JUSTIFICATION

REMOVAL OF INTERNAL CASEMENT WINDOWS

107 HIGH STREET, LINDFIELD, HAYWARDS HEATH, RH16 2HR

Drawing GH342 PL03 Rev C approved drawings under application DM/22/3694 & DM/22/3695

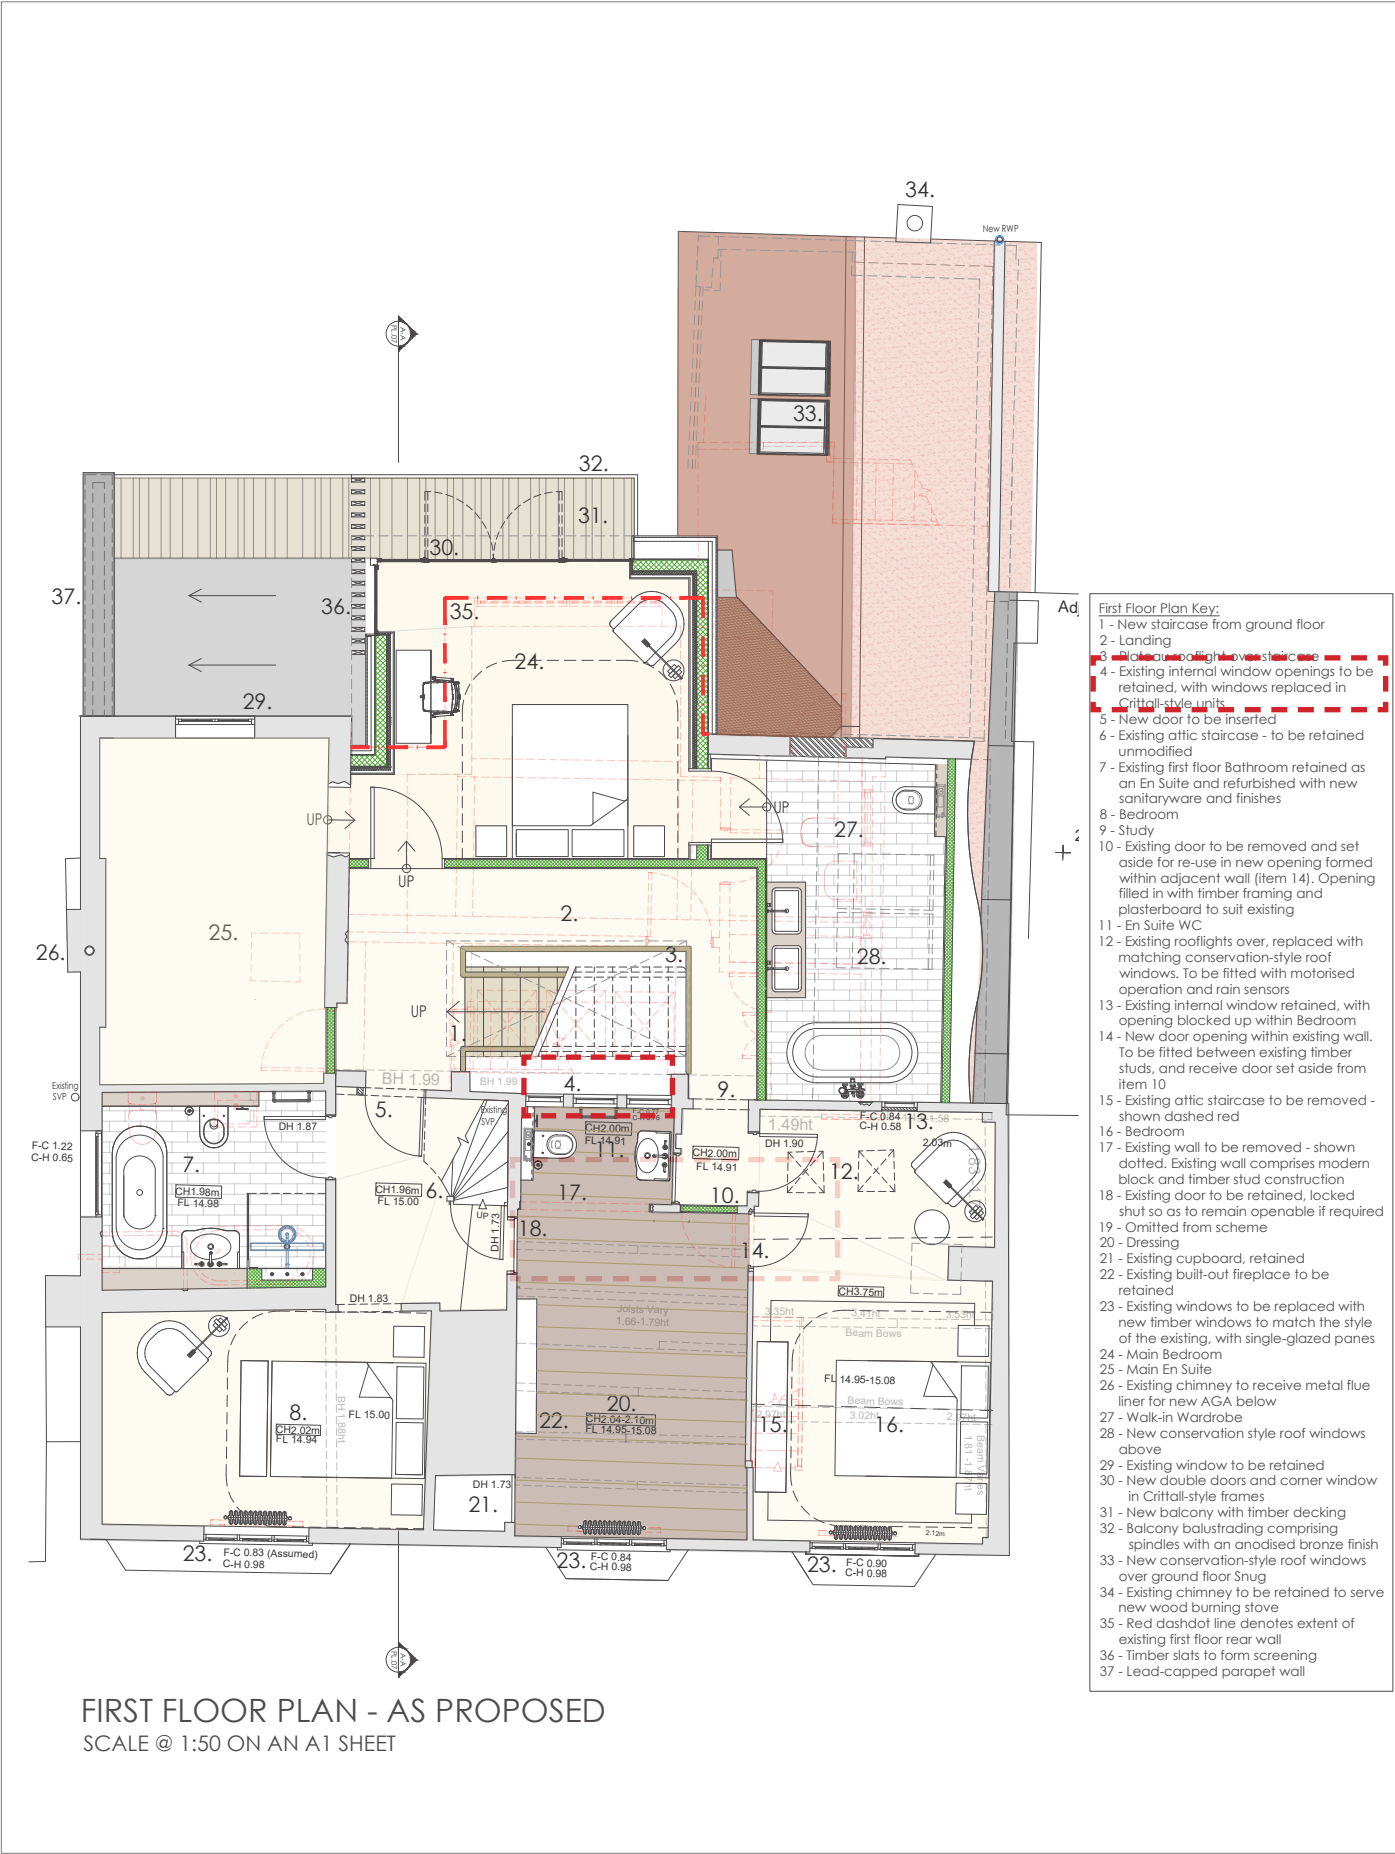
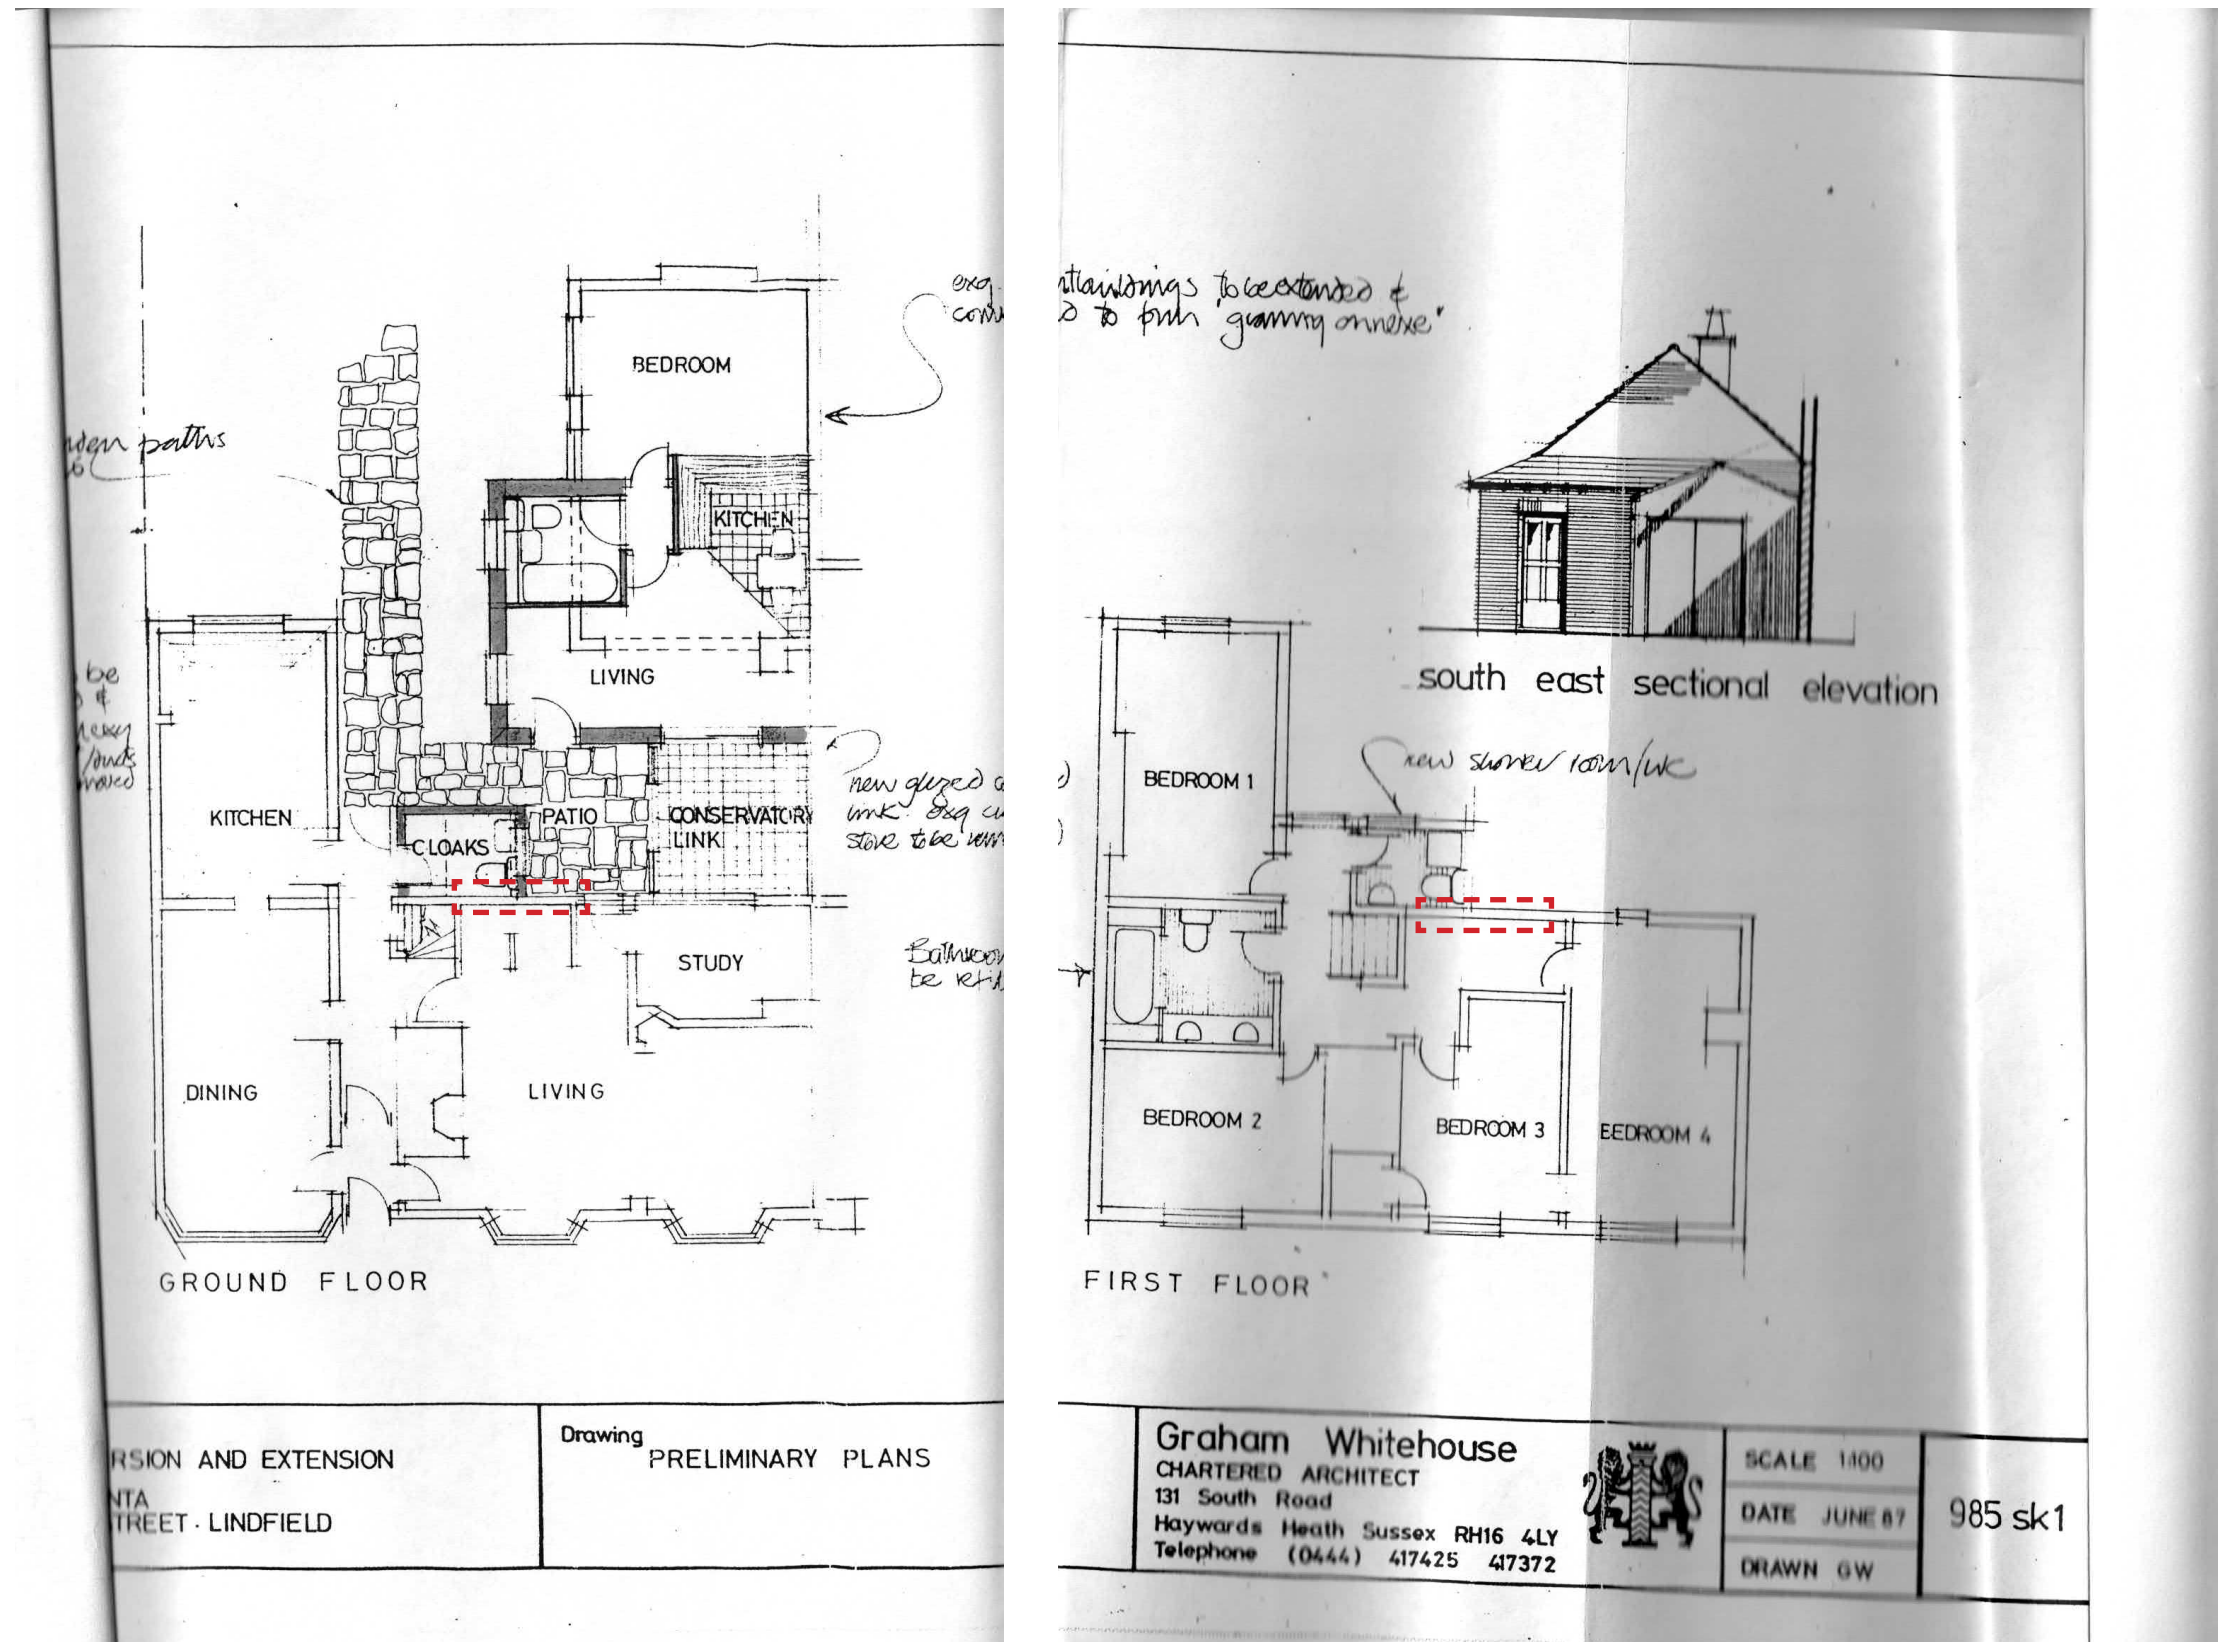
Point 4 of approved drawing GH342 PL03 Rev C confirms removal of existing windows and replacement with crittall-style units. This has been partially implemented by removal of windows. The openings were blocked up with wood wool and lime plaster, which was a more in-keeping solution.

‘4 - Existing internal window openings to be retained, with windows replaced in Crittall-style units’

1. Approved first floor plan - submitted drawings under application DM/22/3694 & DM/22/3695 (planning approved)

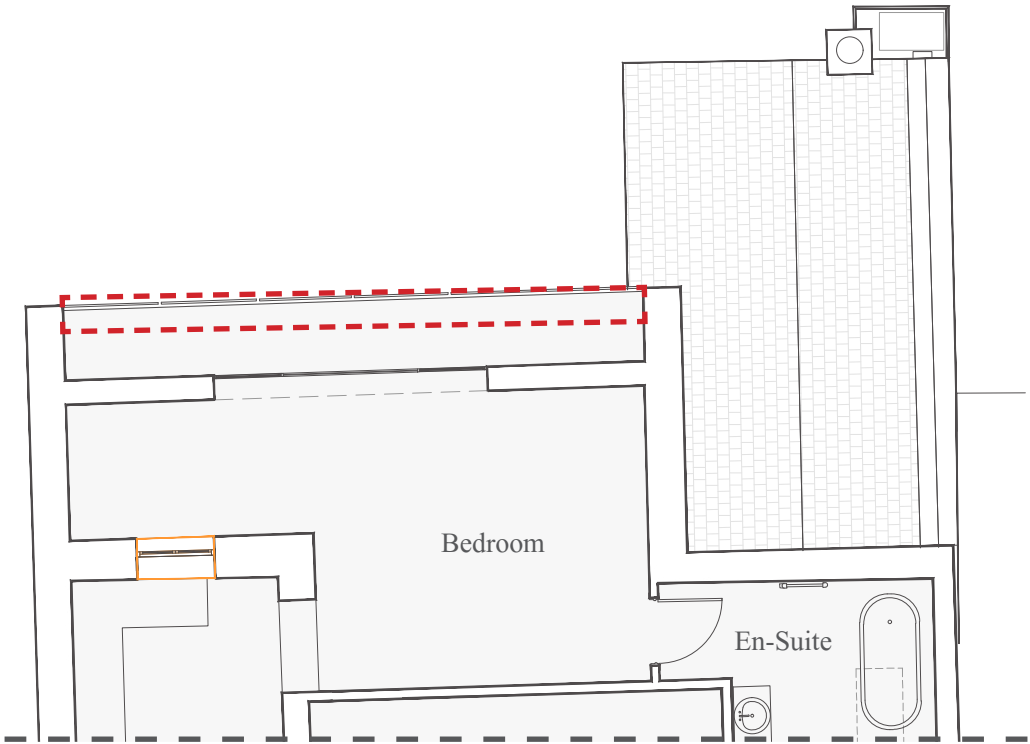
The change to a frameless glazing system is more discreet and visually seamless, reducing the visual obstruction of the overall appearance of the facade, creating less distraction and visual clutter. According to the supporting HCUK Heritage Statement, it is considered to have neutral impact on the significance of the listed building.

As noted previously, the approved drawings of application DM/22/3694 & DM/22/3695 are not consistent. The balustrade appears to span full length of the rear extension on the plan, which is what was implemented.

Proposed roof plan

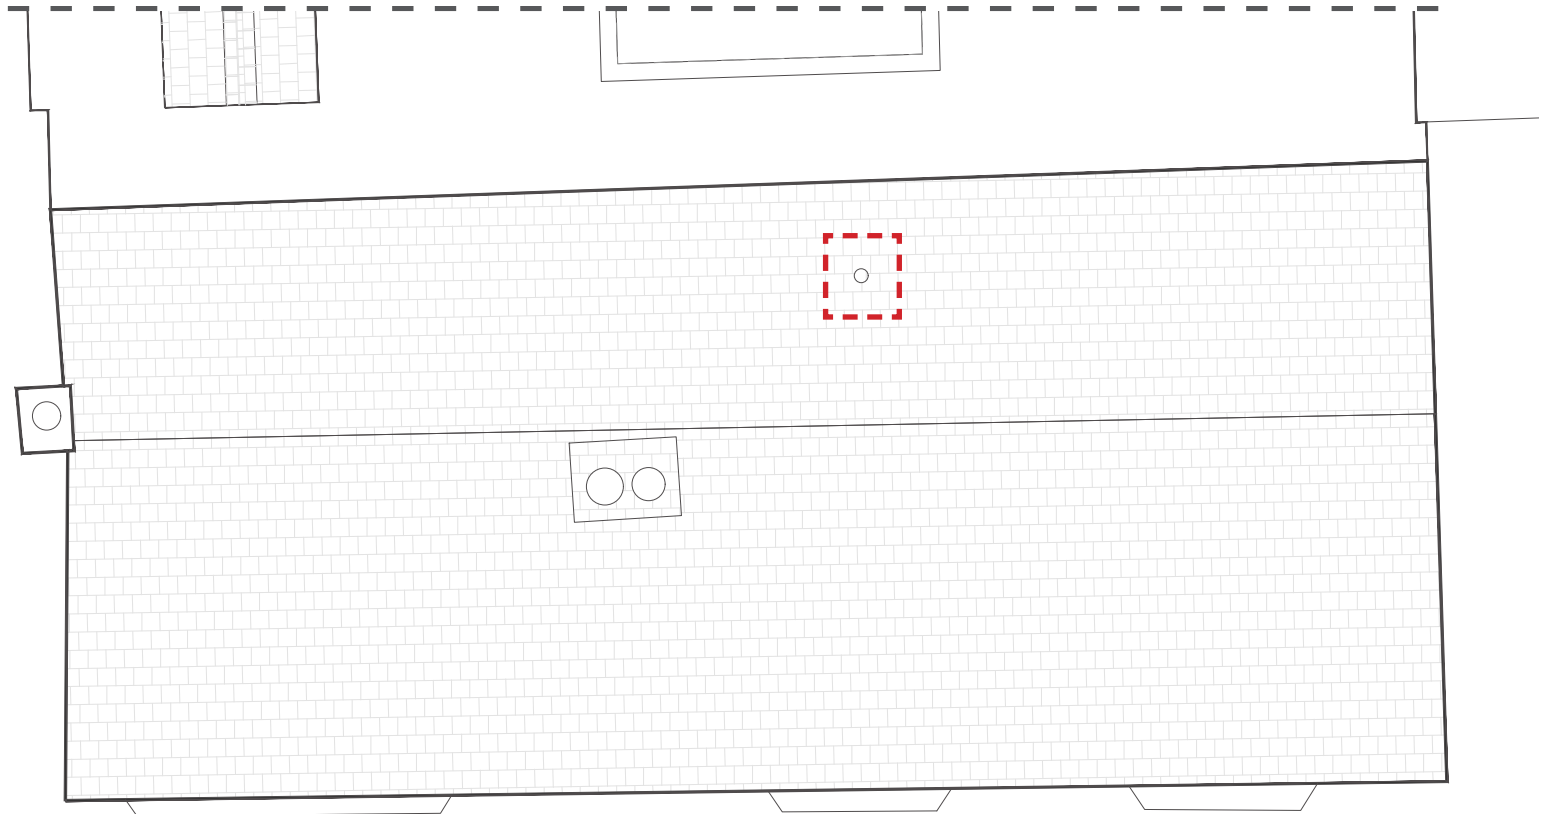
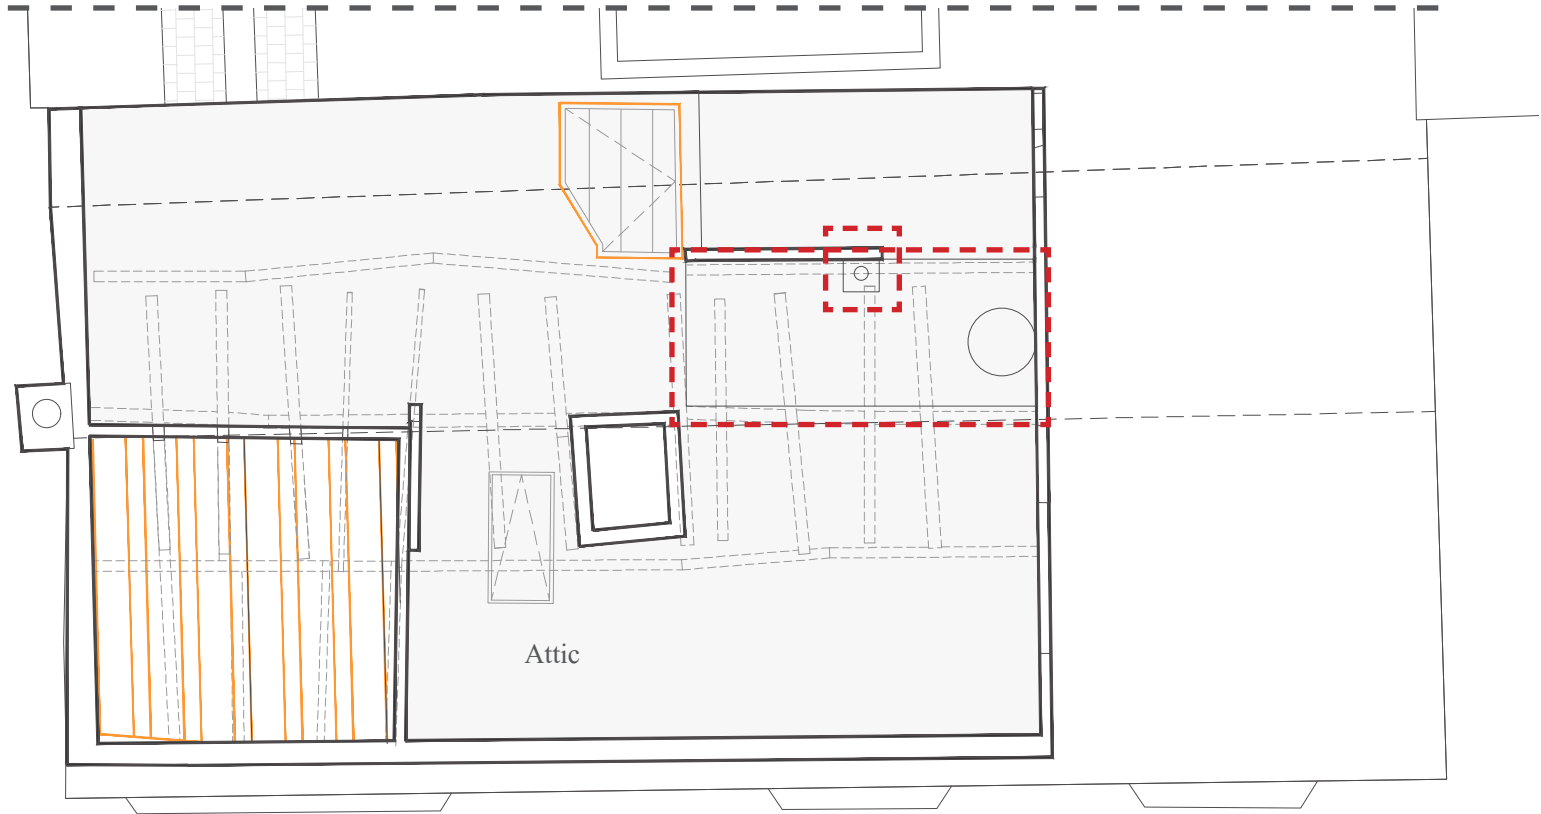
Water cylinder is approx. 600mm diameter and stands on its own supporting timber base spreading the weight over the historic rafters below.
